HYDRAULIC ANALYSIS

Existing Caltrans Drainage Systems Adjacent to CARMAX at National City

August, 2021

HYDRAULIC ANALYSIS FOR EXISTING CALTRANS DRAINAGE SYSTEMS ADJACENT TO CARMAX AT NATIONAL CITY

SHEET TITLE	100-YR INUNDATION AREA EXHIBIT
PROJECT	CARMAX AT NATIONAL CITY I-805 & HWY-54 SAN DIEGO, CA

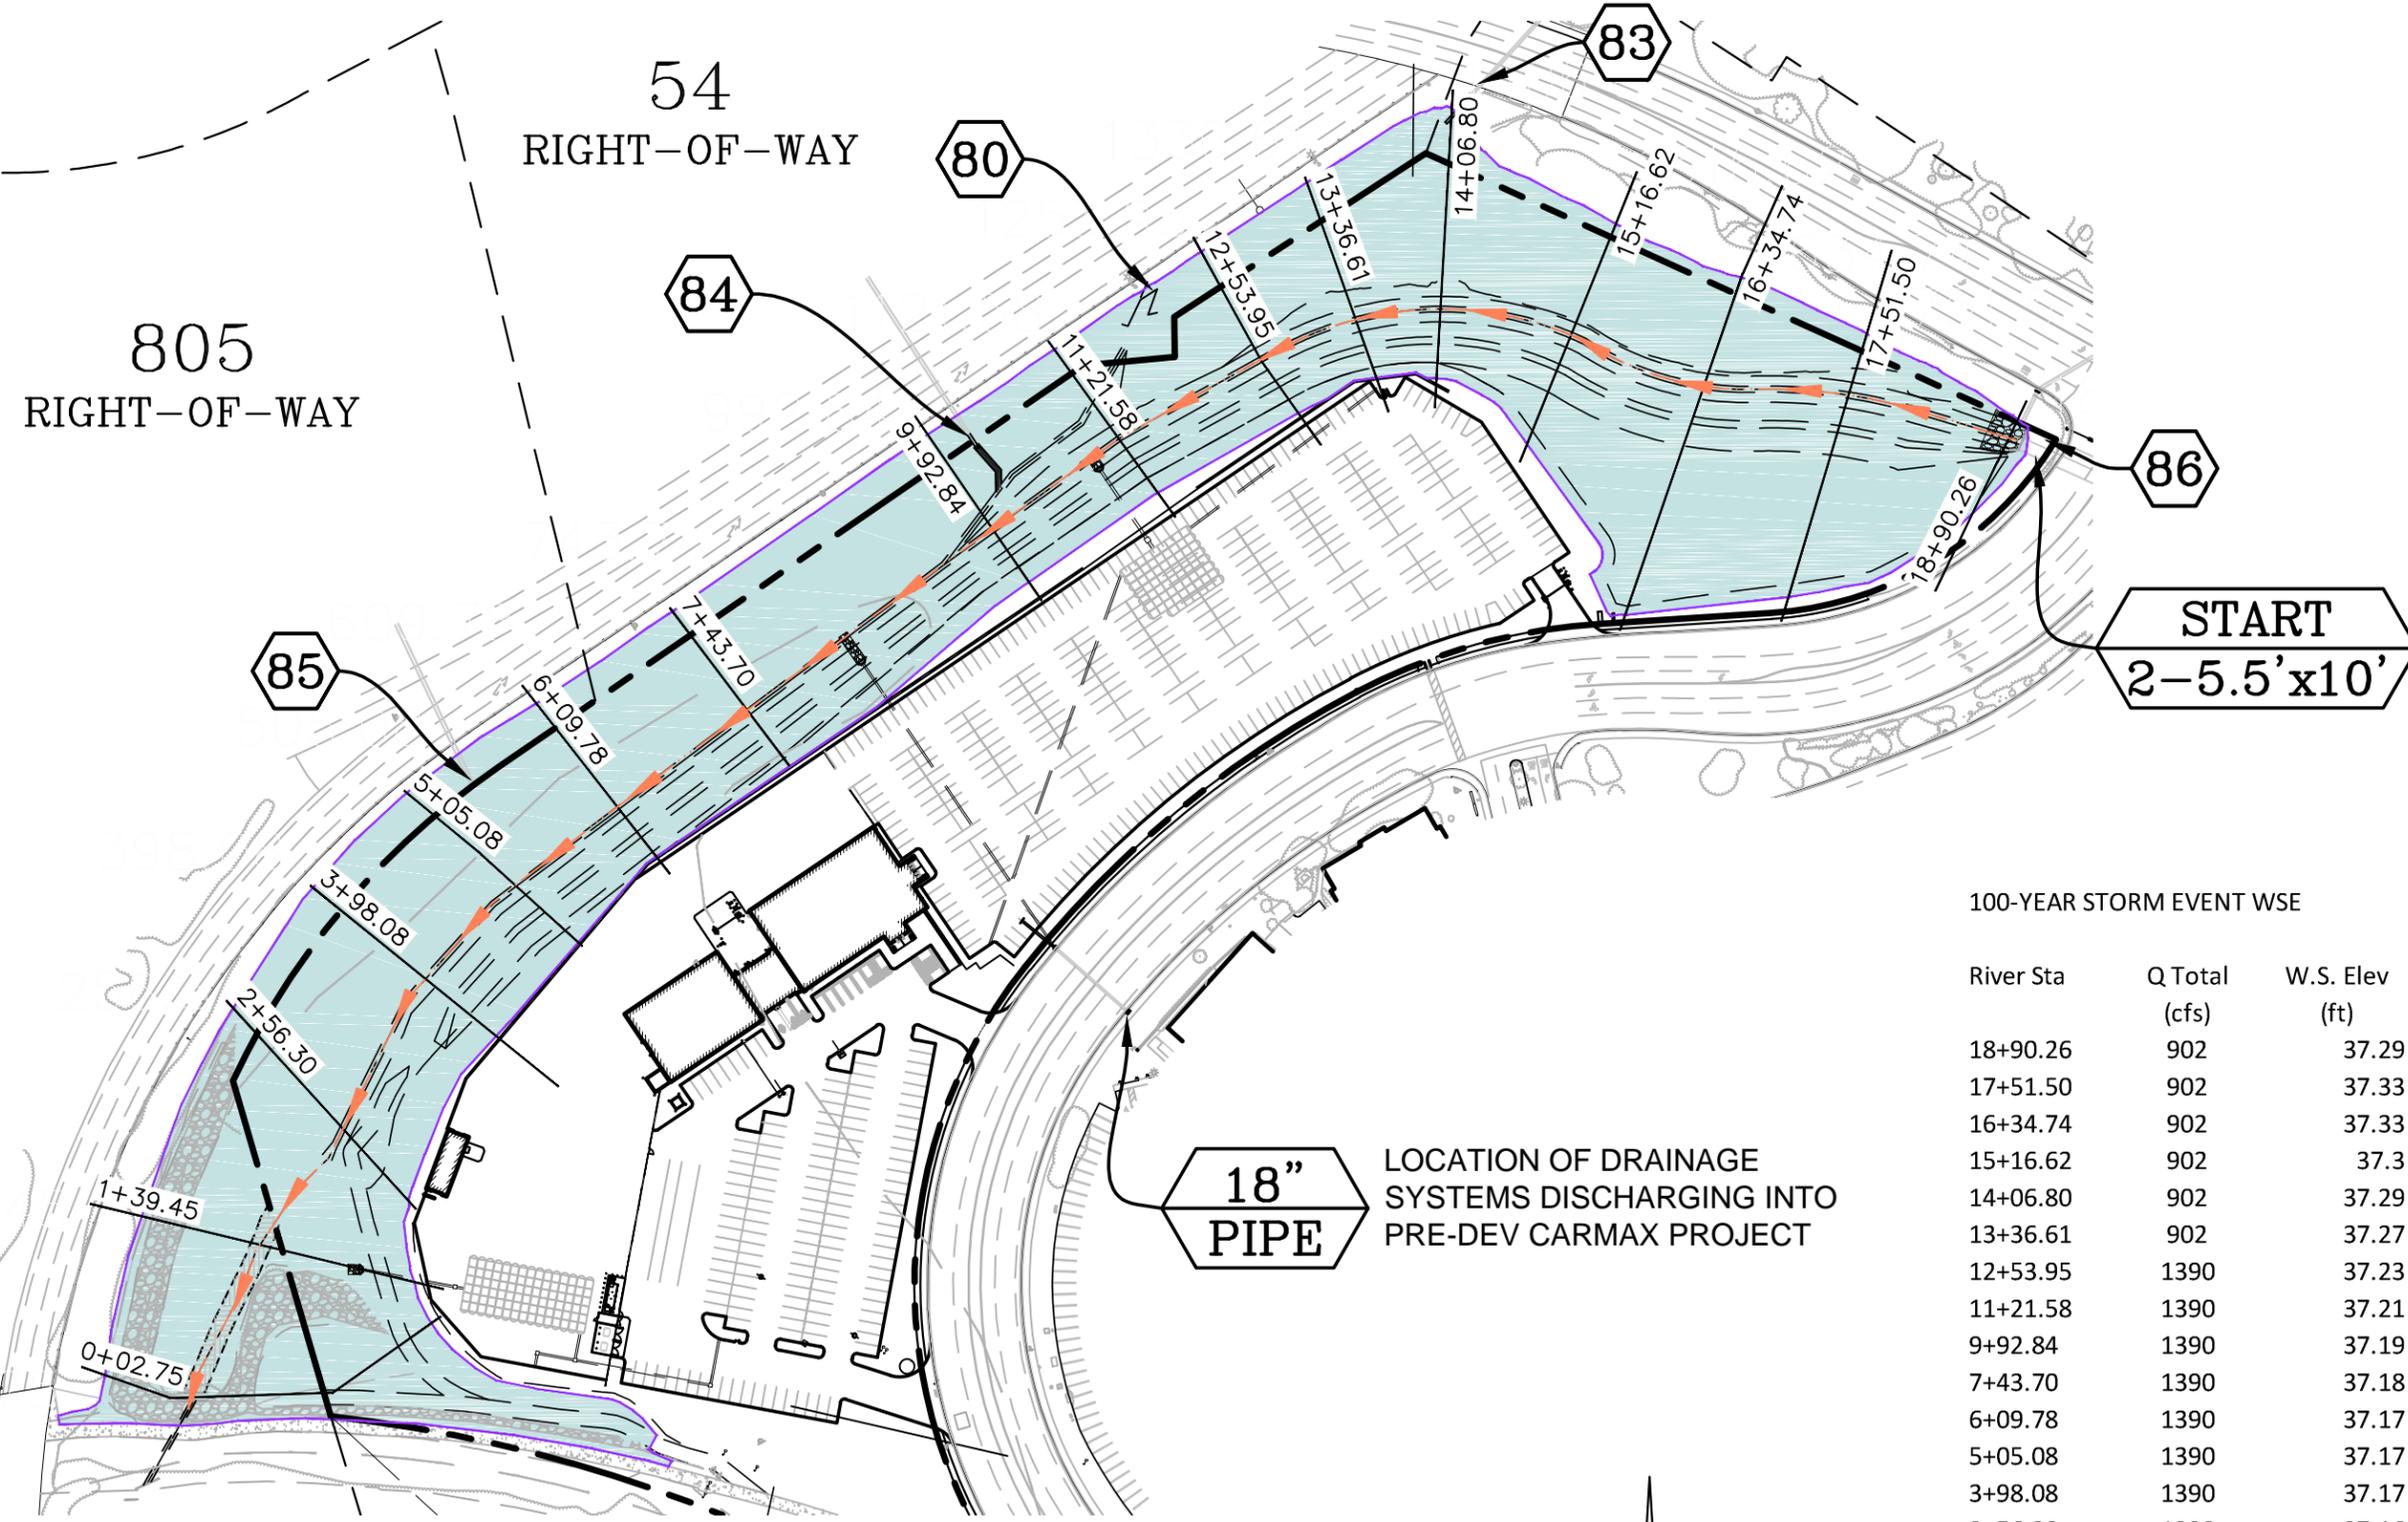
5. The Project footprint shown in the Proposed 100 Year Floodmap Exhibit is inconsistent with the Project footprint shown on the Grading Plans. Please revise the Proposed 100 Year Floodmap Exhibit for consistency with the Grading Plans and make sure to update the cross sections in the HEC-RAS model accordingly.
